Subject: Oconee Nuclear Station  
Docket Nos. 50-269, -270, -287  
Response to Request for Additional Information on  
the Oconee Emergency Power System

REQUEST FOR ADDITIONAL INFORMATION  
OCONEE EMERGENCY ELECTRICAL POWER  
DISTRIBUTION SYSTEM

Graphs for 3LP-17 Breaker and Overload Heaters

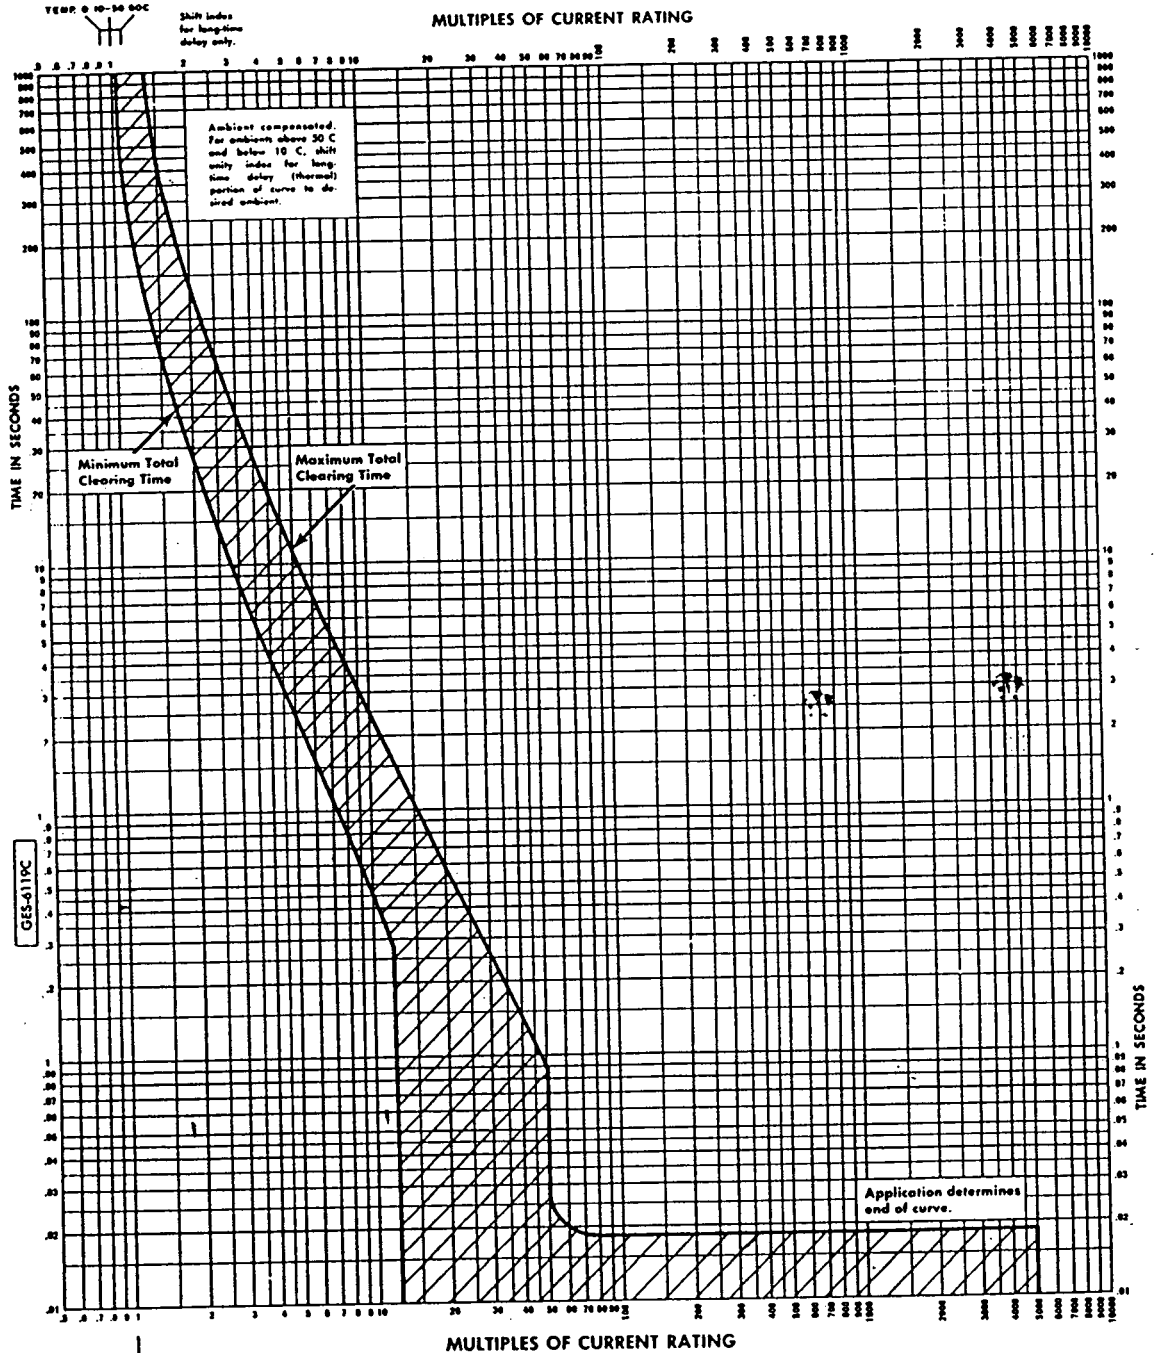
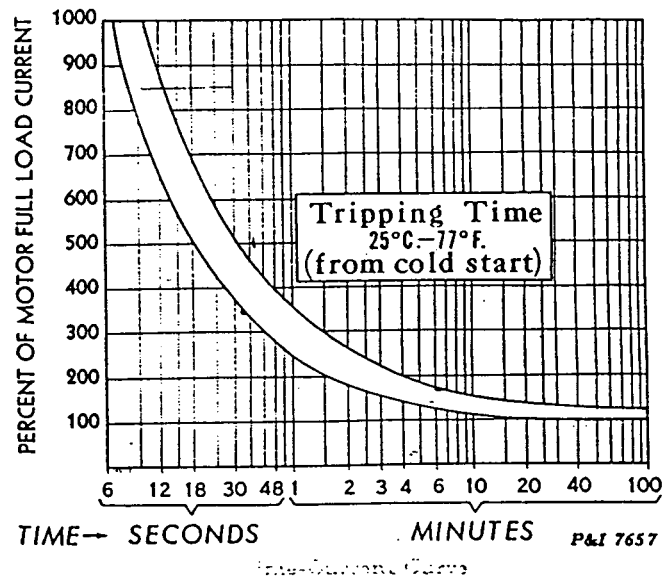
- d. Please provide plots of the valve motor's thermal capability and overload protection, overlaid on the starting inrush current figures shown for this valve during the tests.

Copies of the requested plots are contained in Attachments 2 through 6.

Graphs of 3LP-17 Current During Test 3

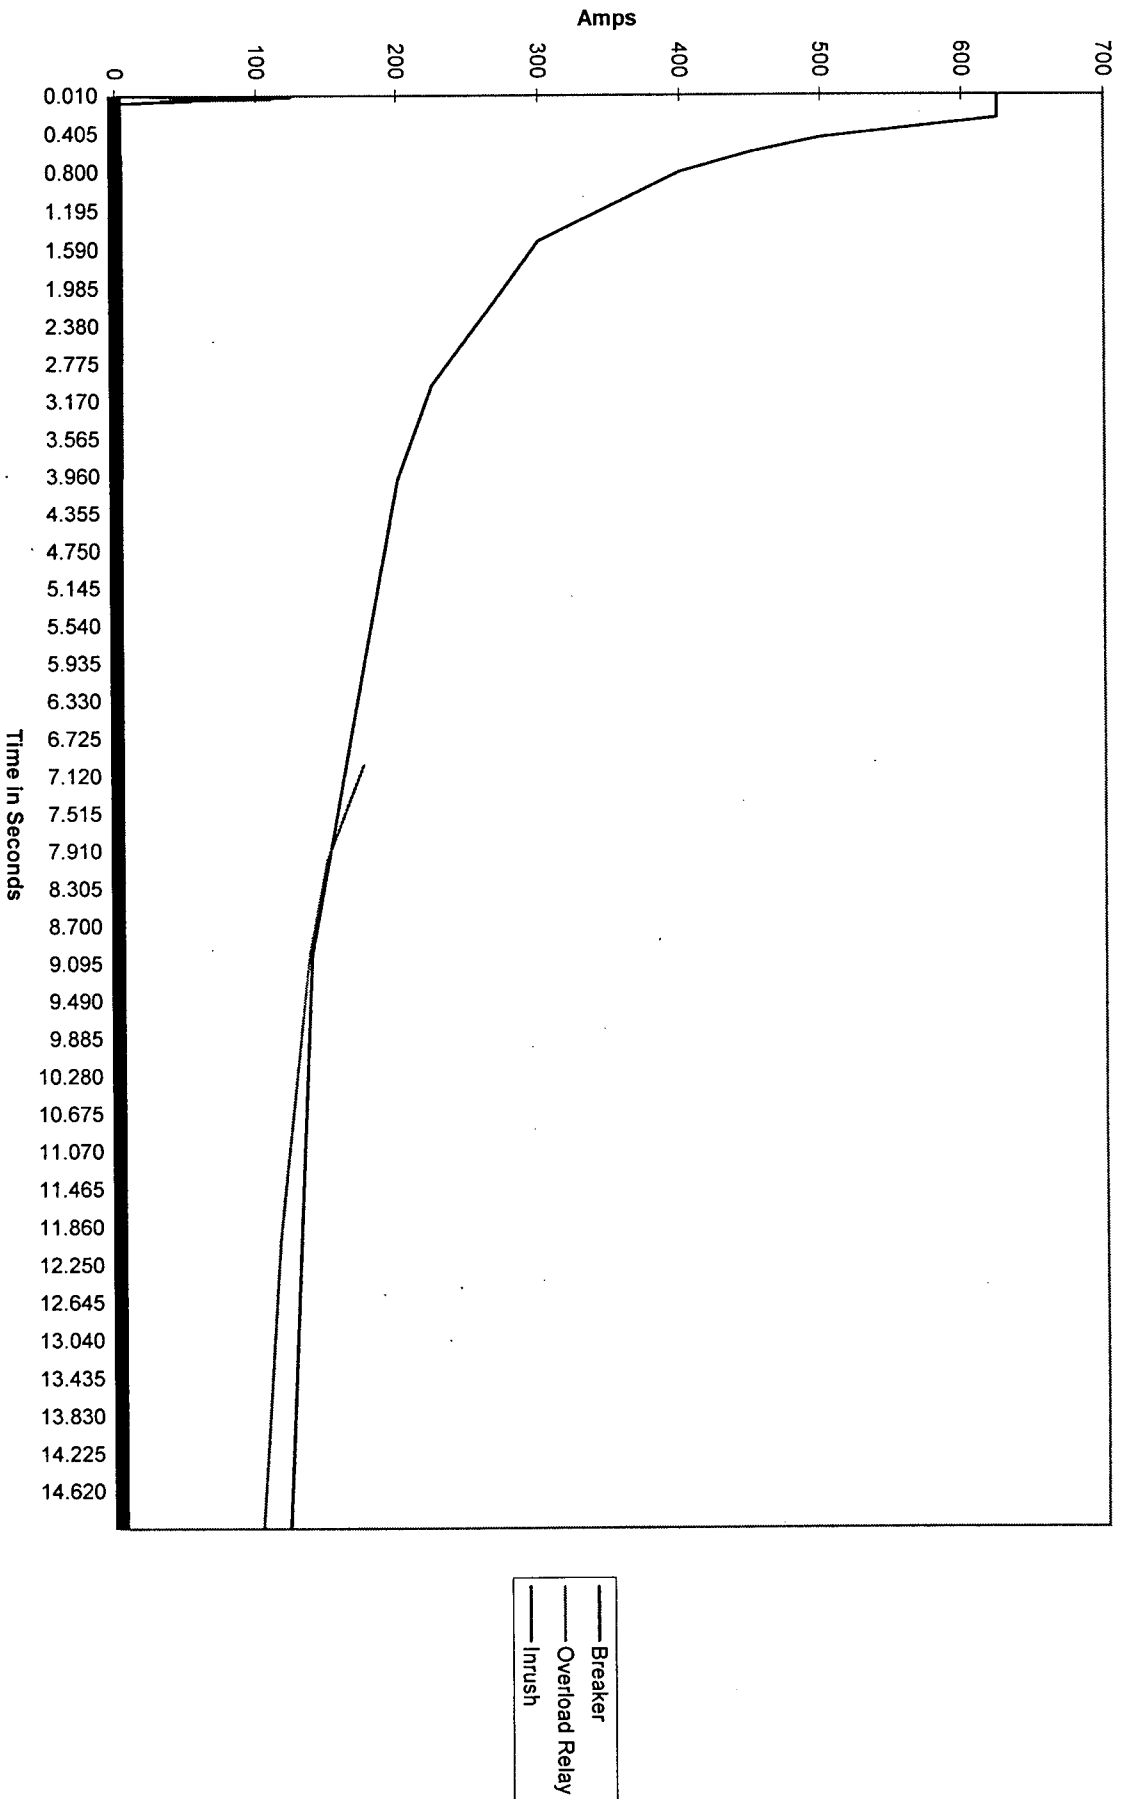
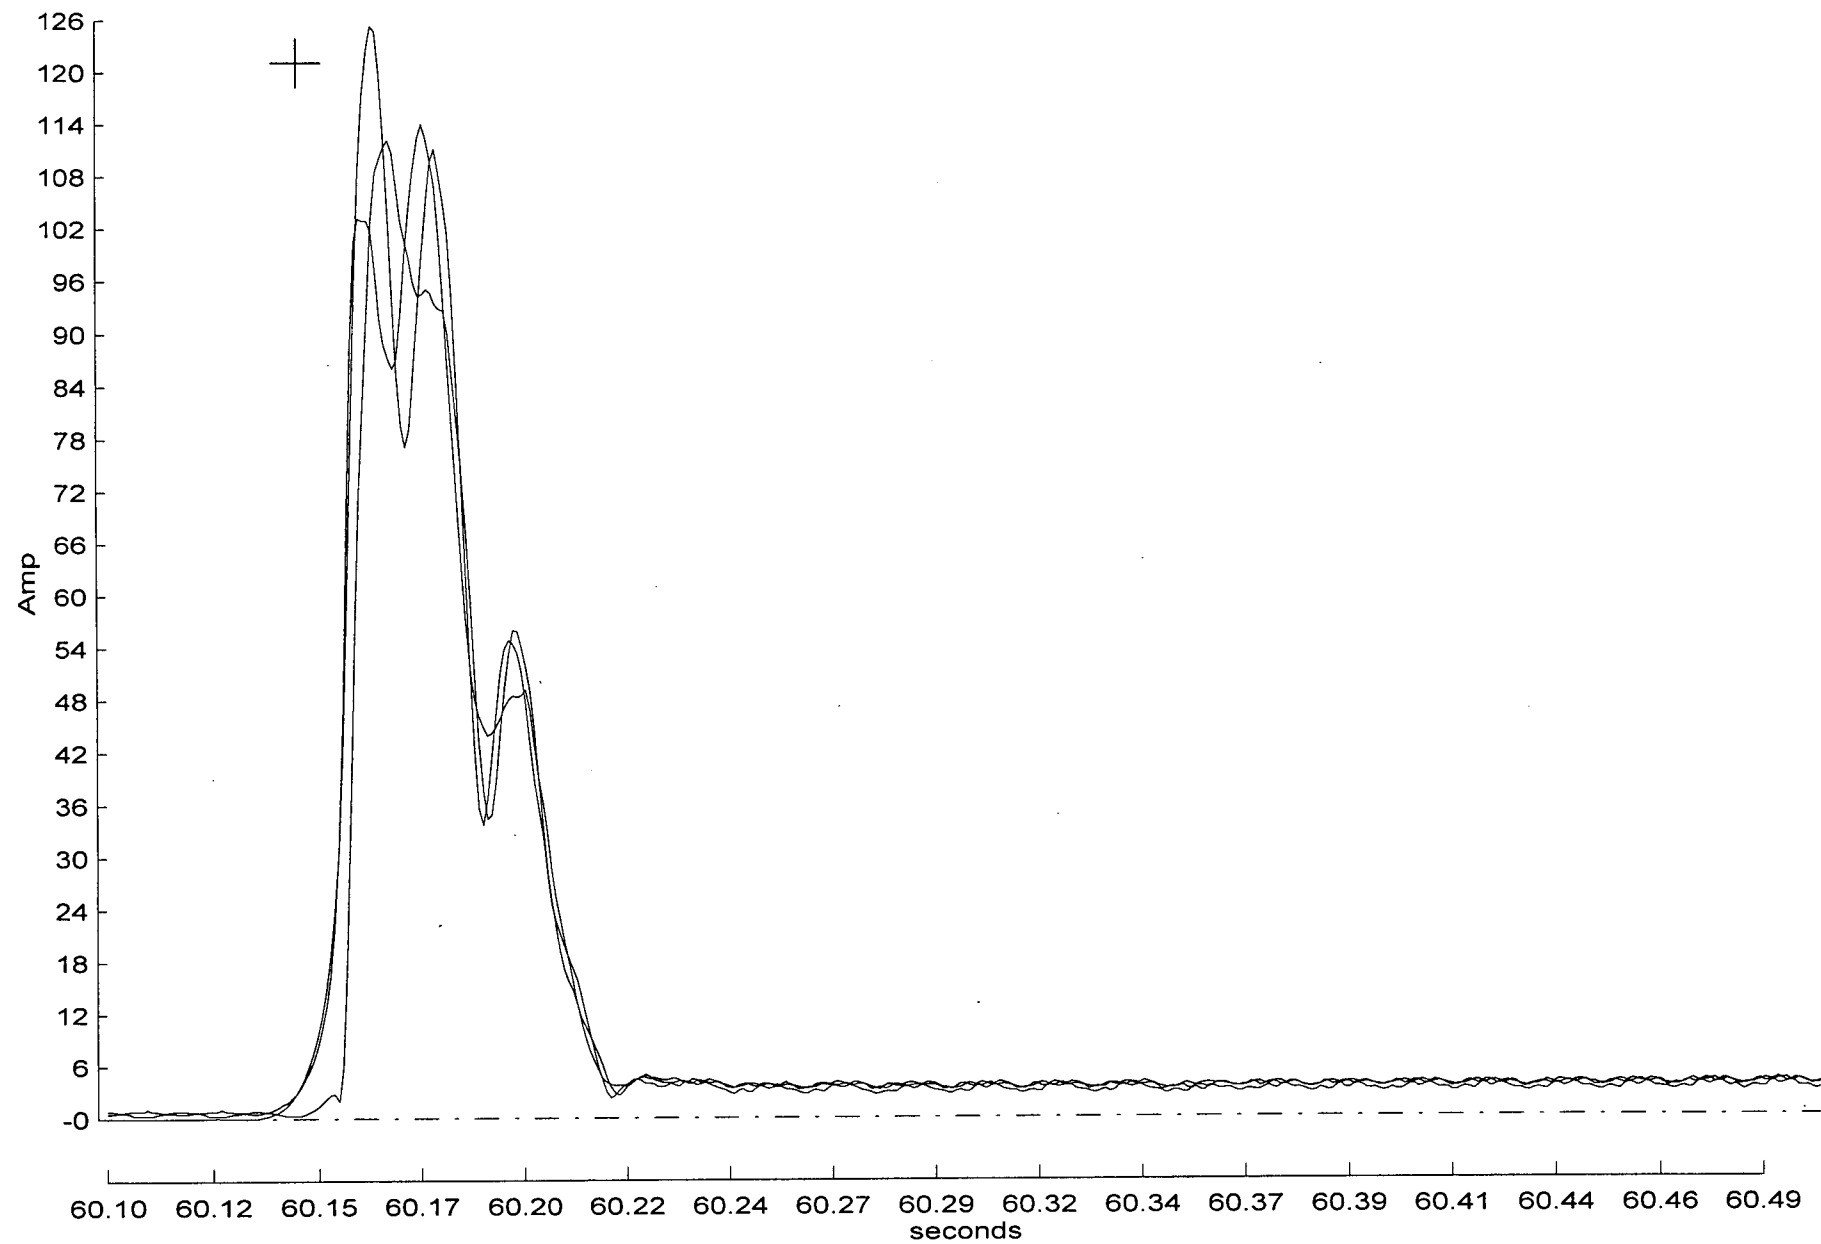
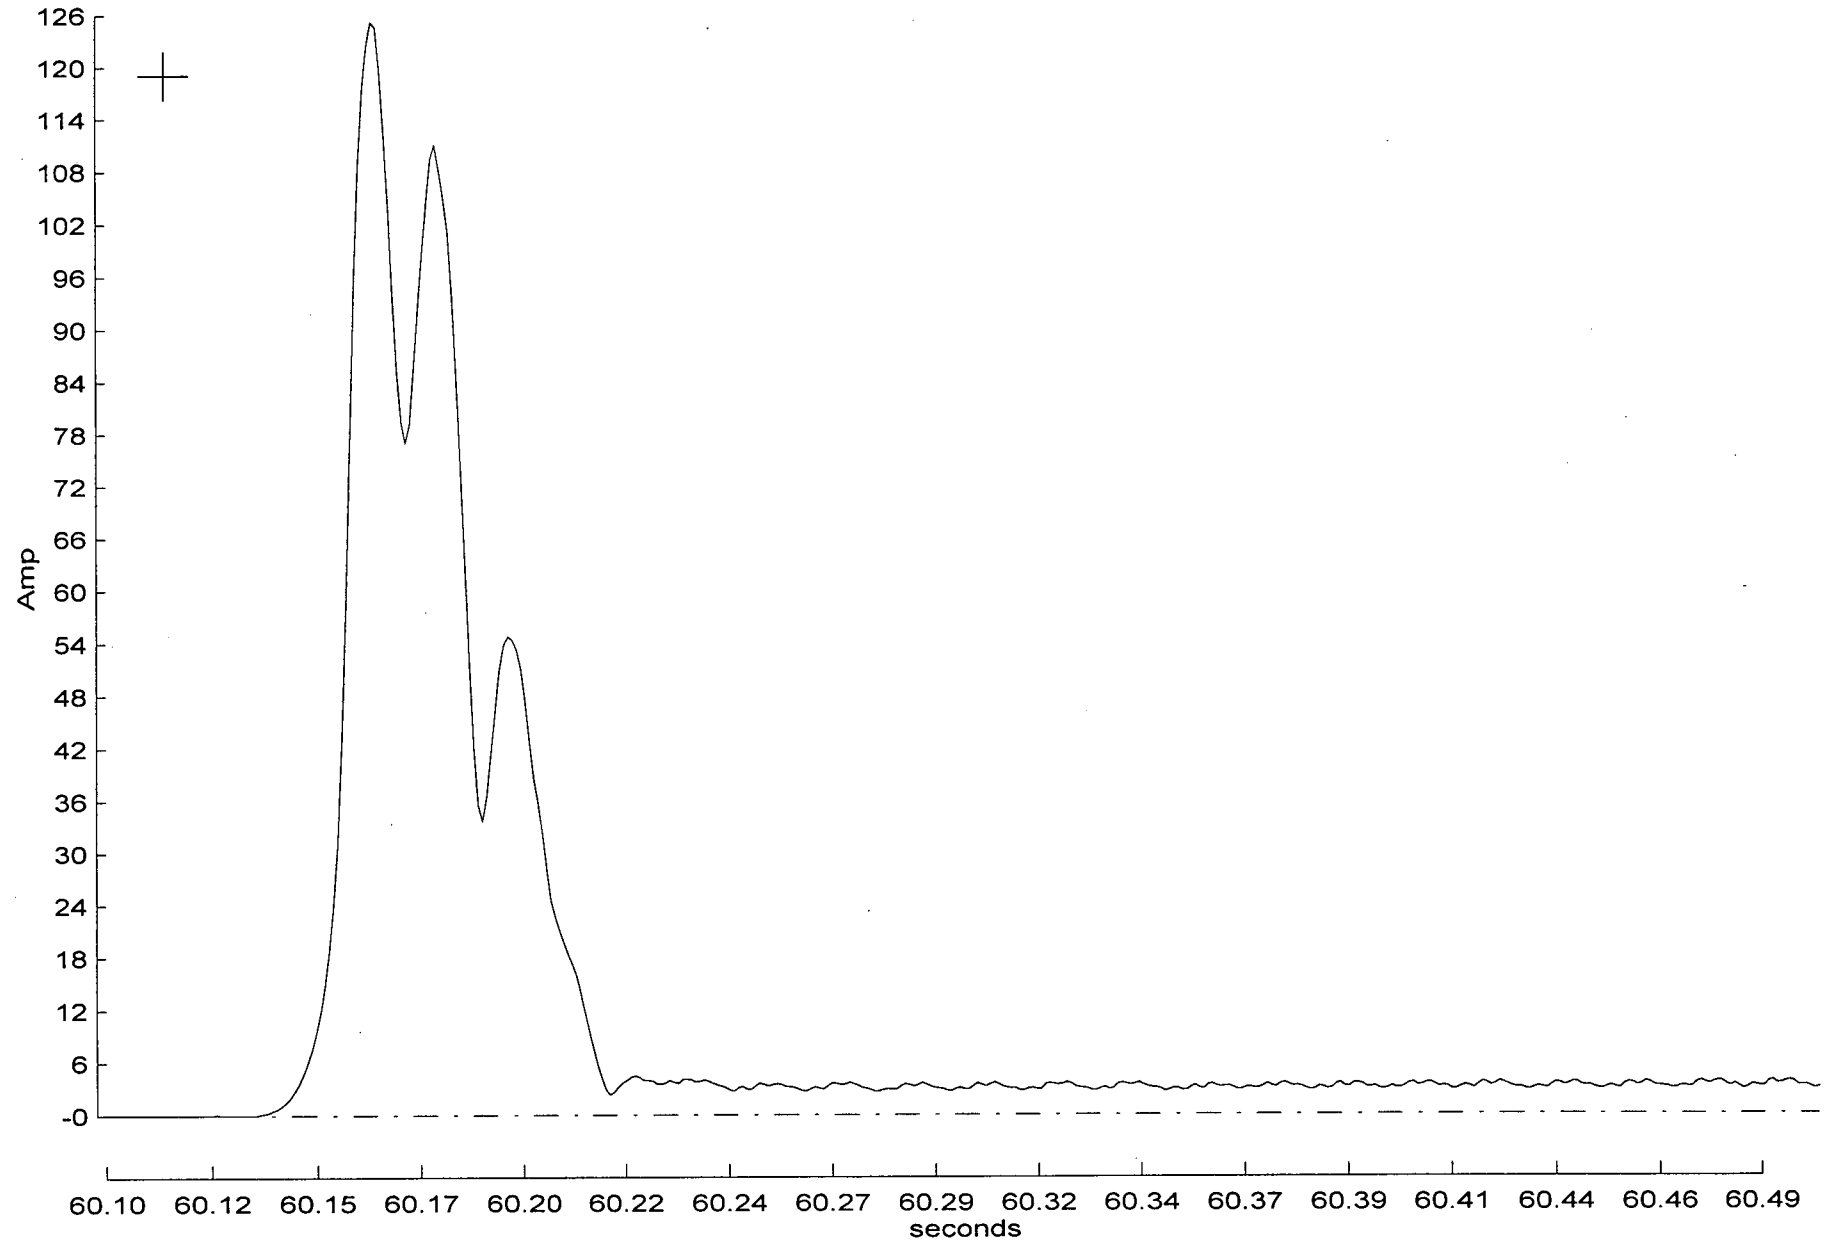
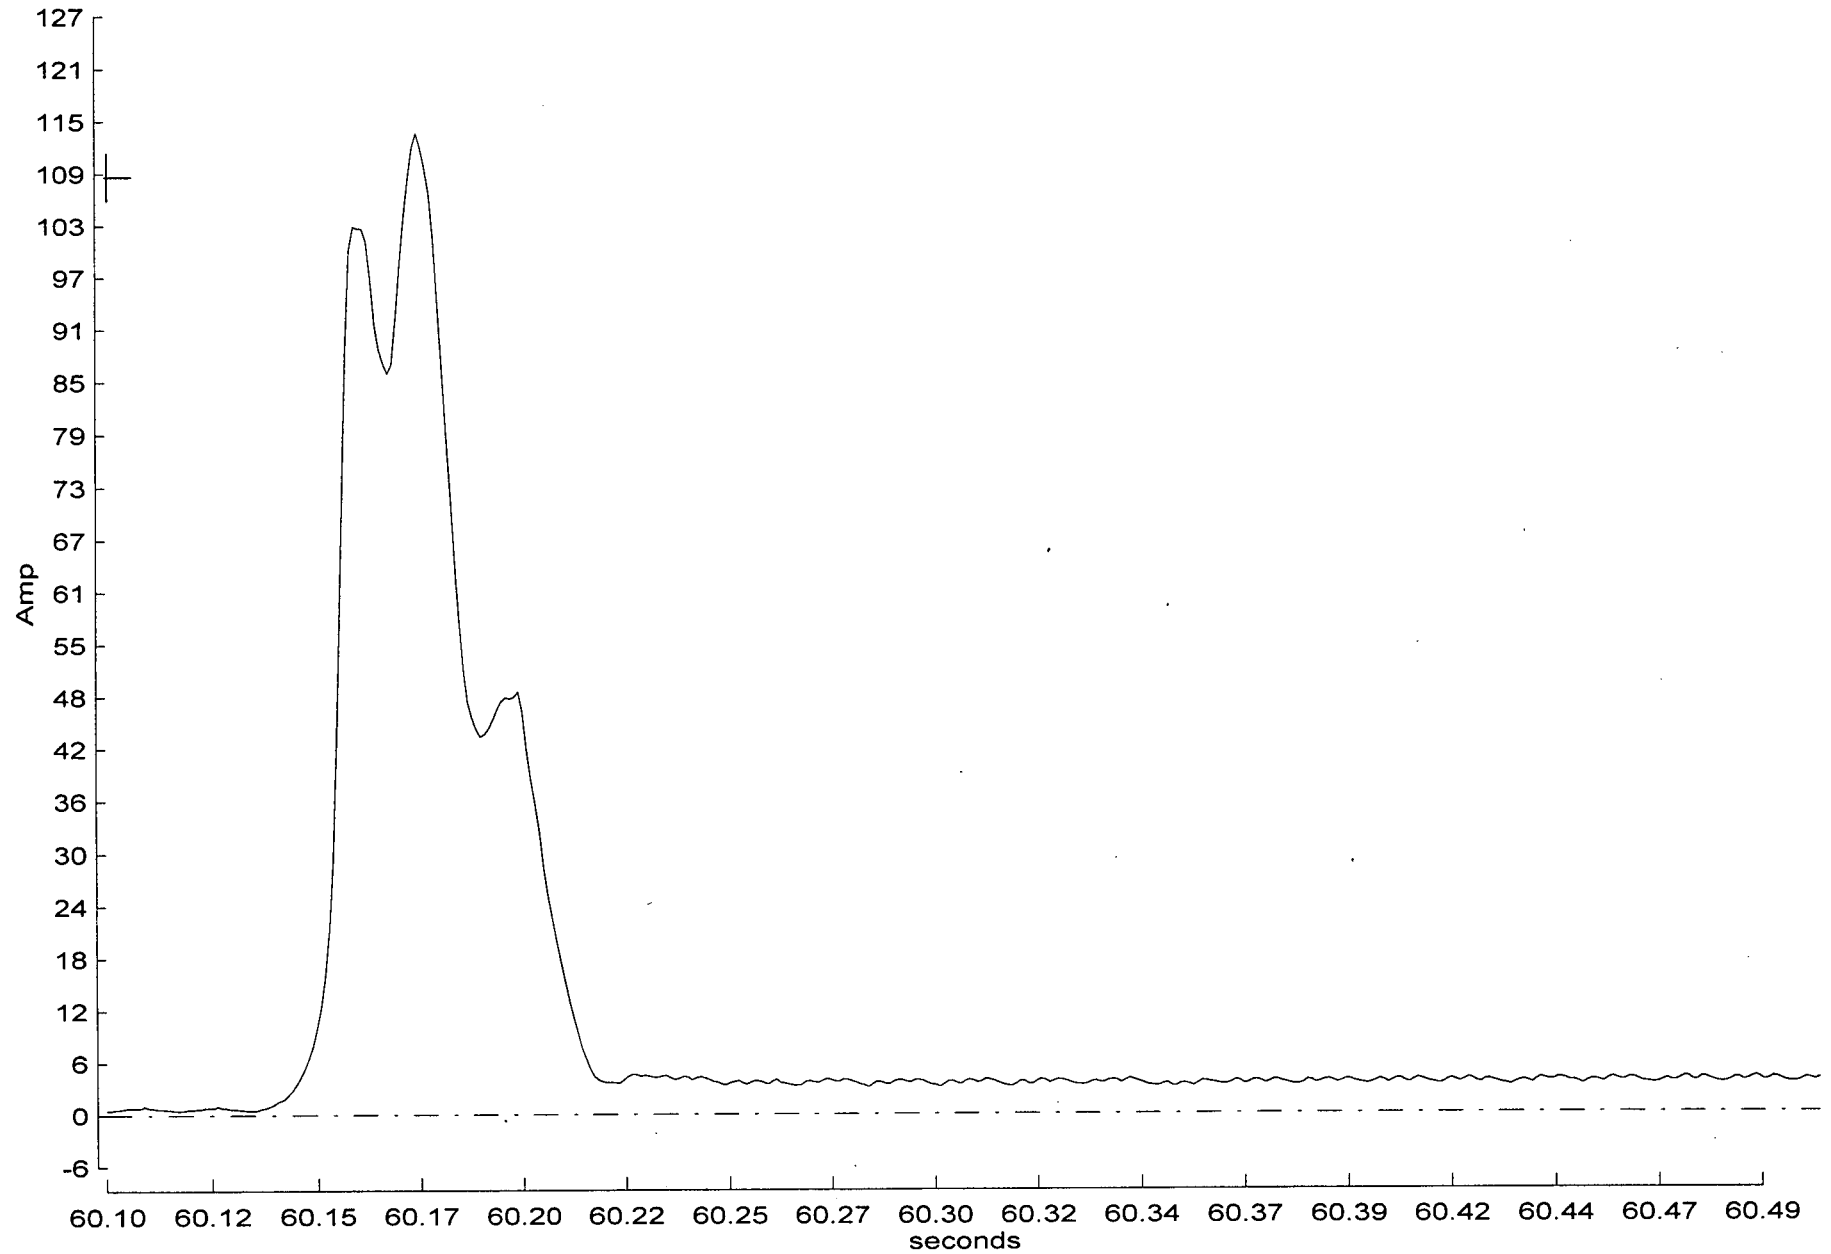
7. Section 5.2.4 of the report states that MOV 3LP-17, which is a gate valve, briefly stalled while starting following contactor pickup during Tests 4, 5, and 6. The stall times were 1.0, 1.0, and 0.4 seconds, respectively, for the three tests. The report indicates that the valve recovered in each case and completed its stroke to its proper ES position; and following inrush, valve stroke was normal and normal hammer-blow and unwedging was observed. We note that in all the LOCA tests where the MOVs are actuated, this particular valve's motor contactor picks up at a voltage value that is quite often one of the largest values seen on the group of valves that are monitored. On that basis, not considering any other variables, it would be expected that this valve would be the least likely to stall.

monitored phases was analyzed for inclusion in the report since all valve stroke events could be identified regardless of which phase was analyzed. A more detailed review of the data for all three monitored phases indicates that the primary reason 3LP-17 appeared to stall was that the 'c' phase starter contact chattered while the 'a' and 'b' phase contacts maintained a stable energized state. Therefore, the 'a' and 'b' phases (one of which was included in the report) indicated stall conditions until the 'c' phase contact maintained a stable energized state. Once all three phases were energized, 3LP-17 stroked as expected. In retrospect, 3LP-17 did not actually stall as originally thought. Attachment 6 contains the plots of the current data for 3LP-17 which indicate the chattering of the 'c' phase contact.
